Research Report 1524

# MANPRINT Evaluation: AN/TRC-170 Digital Troposcatter Radio System

Gregory S. Krohn and Samuel E. Bowser  
Essex Corporation

June 1989

Figure 18. An example of the type of manipulation task that could be performed more rapidly by crewmen using a stepladder or platform.

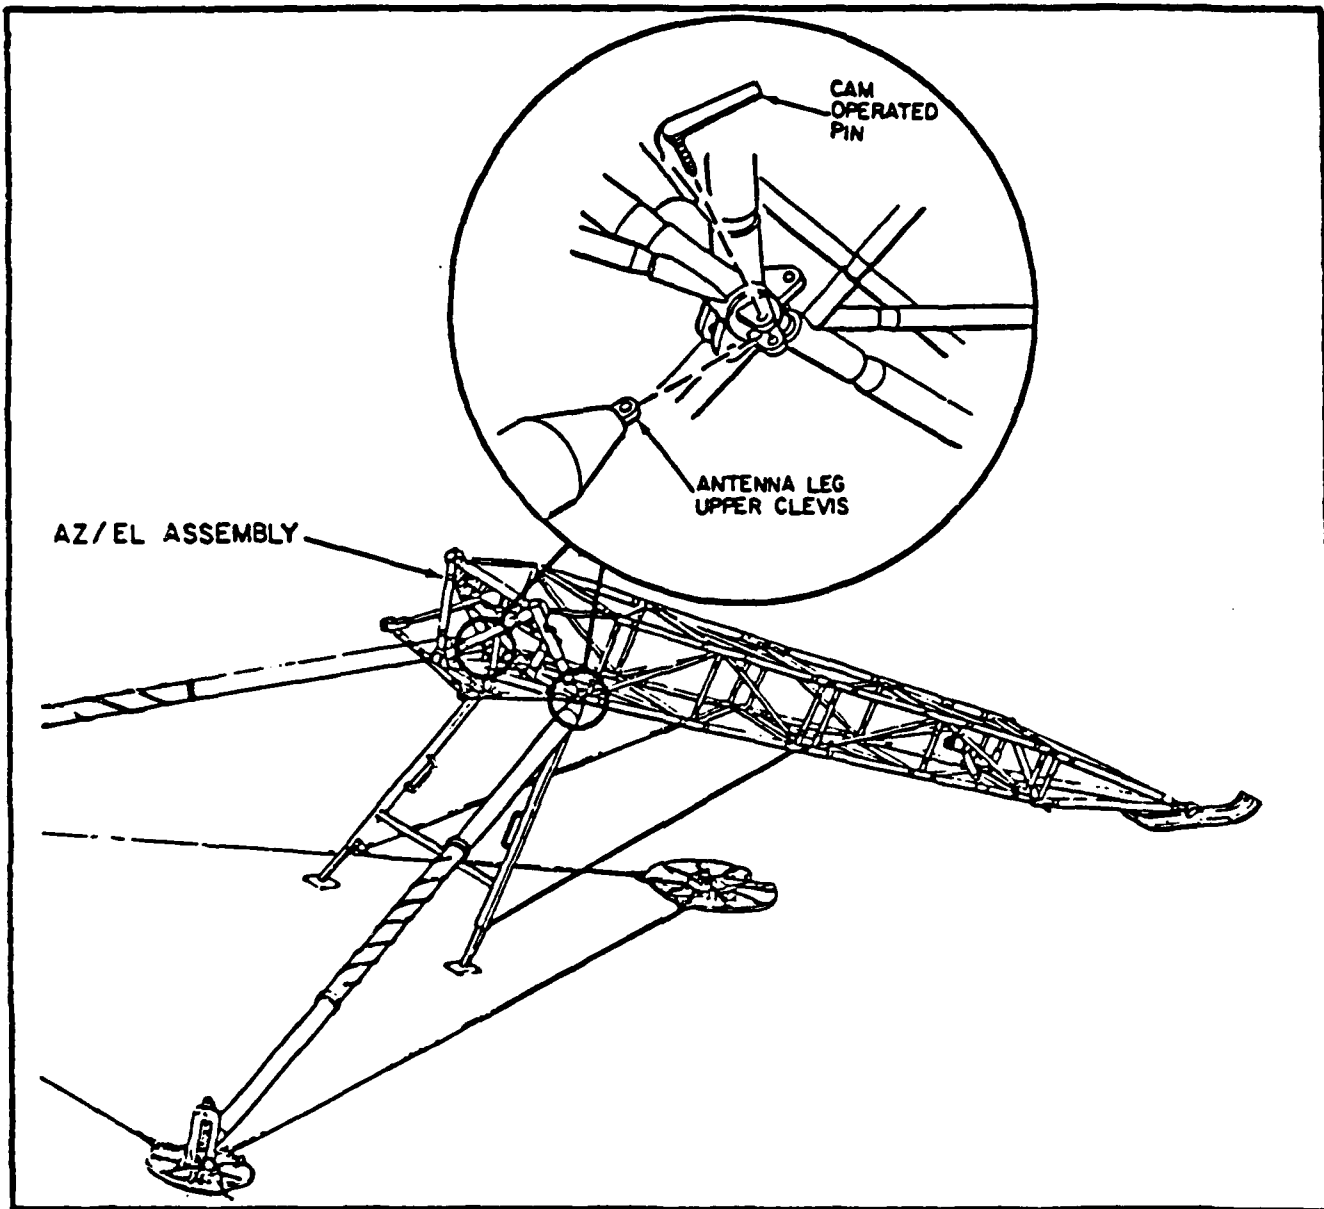
Description of the Problem: Figure 18 shows the type of manipulation task that must be performed on the 9.5-ft antenna. Figure 19 shows the antenna hand crank that is difficult to reach. The assembly of the 9.5-ft antenna has several situations where personnel need to extend their reach. There is no ladder or other approved stand available on the AN/TRC-170. The situations include the following:

Potential Solutions: Provide a stand as standard equipment issue for the AN/TRC-170(V2). It is recommended that at least a 3-ft high stand or ladder be supplied.

Figure 20. The interior of the low-profile pallet showing the location of the accessory alignment kit.

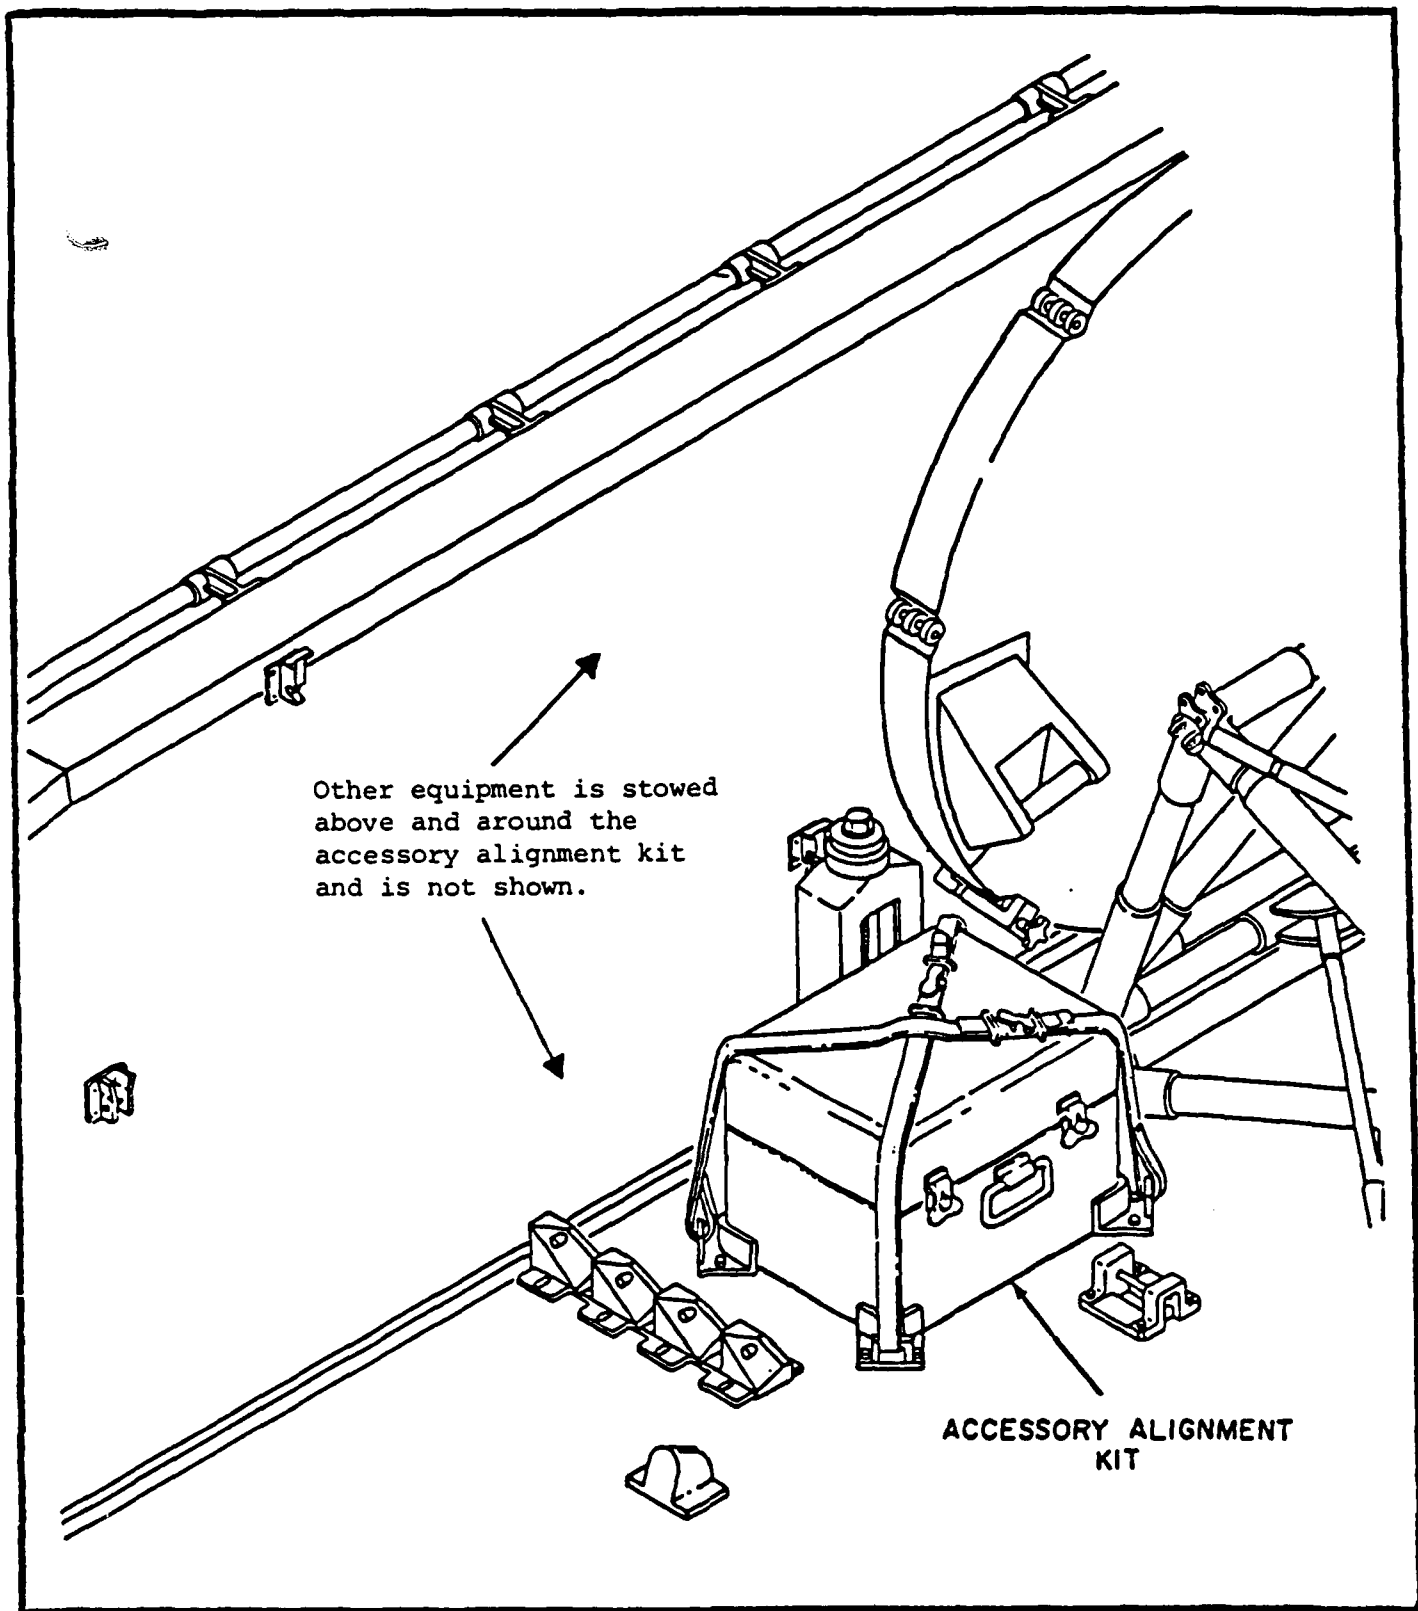
Description of the Problem: Figure 20 shows the location of the accessory kit on the low-profile pallet. The location of the accessory kit, which includes the pocket transit on the low-profile pallet, is located on the bottom of the pallet beneath the antenna truss structures. The pocket transit is the first item needed for site layout. The crew must remove the canvas cover from the pallet and push antenna parts out of the way to retrieve the kit.

Potential Solutions: The accessory kit should be placed in the shelter near the door or in the truck cab area for easy access.

Figure 21. The low-profile pallet which was mounted on a 2.5-ton truck.

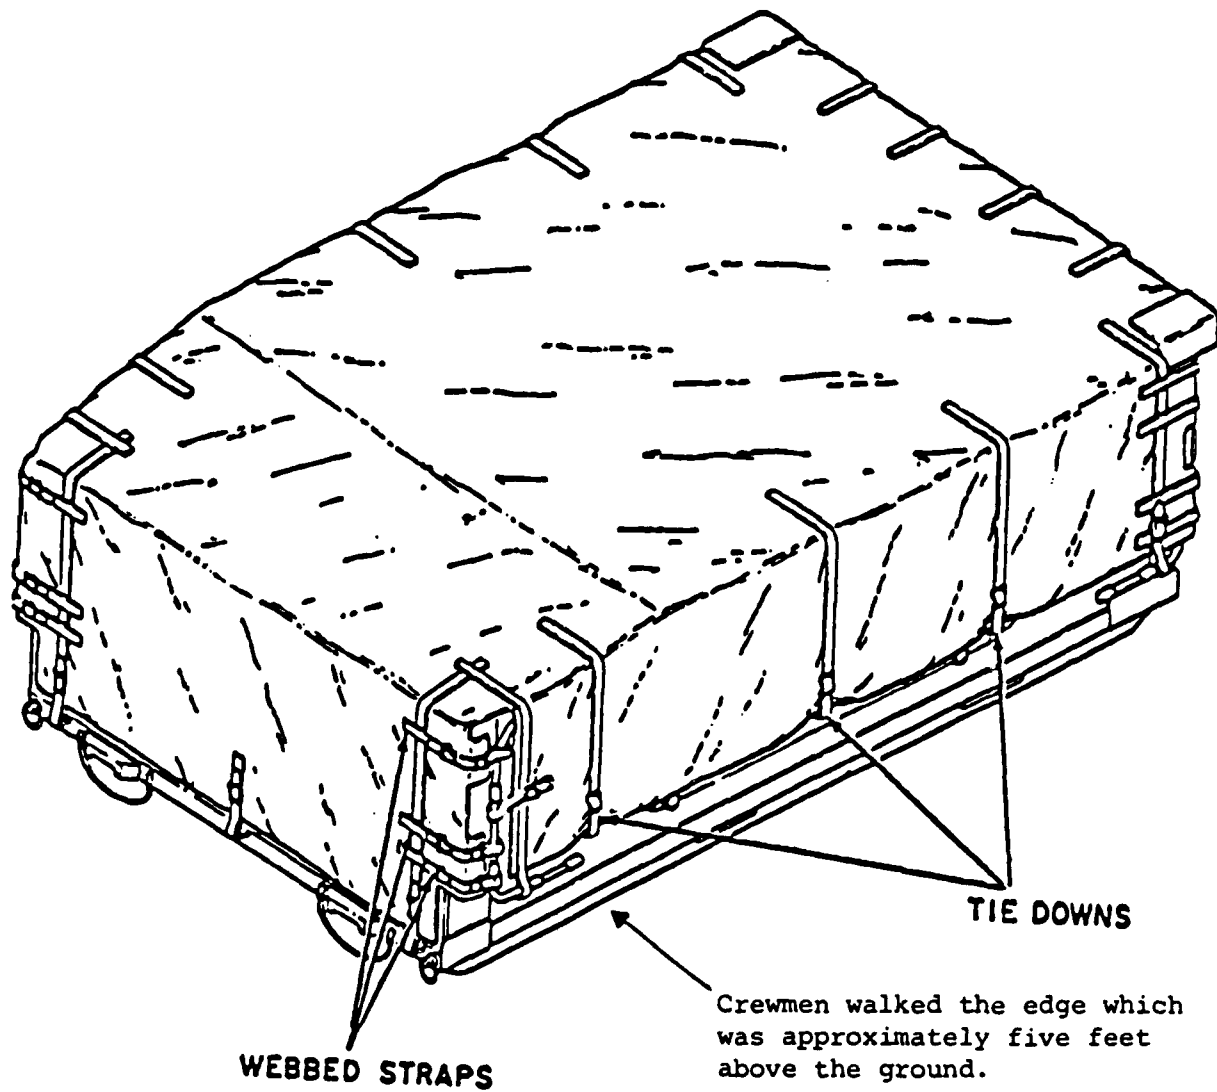
Description of the Problem: Figure 21 shows the low-profile pallet secured for transport. Crewmen must walk on the outside edge (3-in width) of the low-profile pallet in order to remove the canvas and ropes. Crew members must assume unsafe positions when removing the canvas cover and retrieving the accessory kit.

Potential Solutions: The canvas cover over the low-profile pallet could be provided with a drawstring arrangement so that personnel would not have to climb the side of the truck. The load on the low-profile pallet should be redistributed to facilitate loading and unloading, and consideration should be given to moving some of the load to the shelter.
